STATE OF MAINE
DEPARTMENT OF AGRICULTURE, CONSERVATION & FORESTRY
LAND USE PLANNING COMMISSION
22 STATE HOUSE STATION
AUGUSTA, MAINE 04333-022

May 27, 2020

The Land Use Planning Commission has reviewed the additional information submitted by Wolfden Mt. Chase, LLC. on May 1, 2020 for Zoning Petition 779, Pickett Mountain Mine. Because the additional information responds, in part, to both the request for additional information in the Commission's April 15, 2020 letter and items requested in the Commission's March 6, 2020 letter, we are providing an updated, comprehensive list of information that the Commission needs to begin a thorough analysis of the petition. Based on this latest review, there are still several items requiring revision or clarification before the petition can be deemed complete for processing. In addition, there are other outstanding information requests, and a few new questions based on the revised submittals to date, that the Commission needs answered to complete its review.

**Excerpts from ZP 779, Pickett Mountain Mine Petition
With LUPC Highlights**

Viewshed of Operations Area (Green)

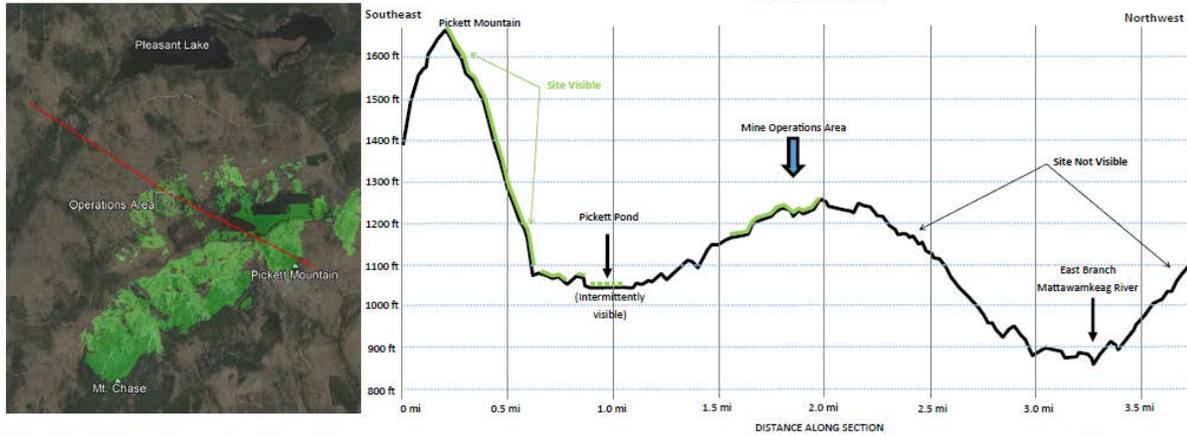
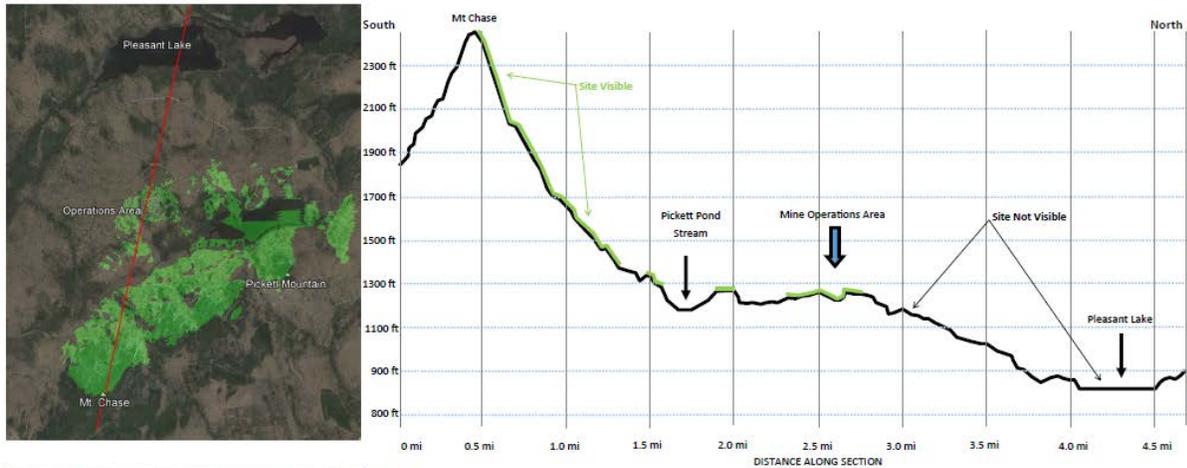
- b. Visual Impact.
 - i. Include more detailed information describing the method used to complete the viewshed analysis, including what software was used and any assumptions that were made in the analysis. Explain why a height of 10 meters was used for the analysis. Given the height of the proposed concentrator building of 60 feet, it appears that 18 meters is the more appropriate figure to use.

- ii. Provide a revised map for the desktop viewshed analysis that labels scenic resources from which there may be views of the proposed development including campsites, hiking trails, boat launches, waterbodies, etc.

- iii. LUPC staff recommends that a qualified professional with experience in visual impact analysis provide an interpretation of the results of the desktop viewshed analysis.
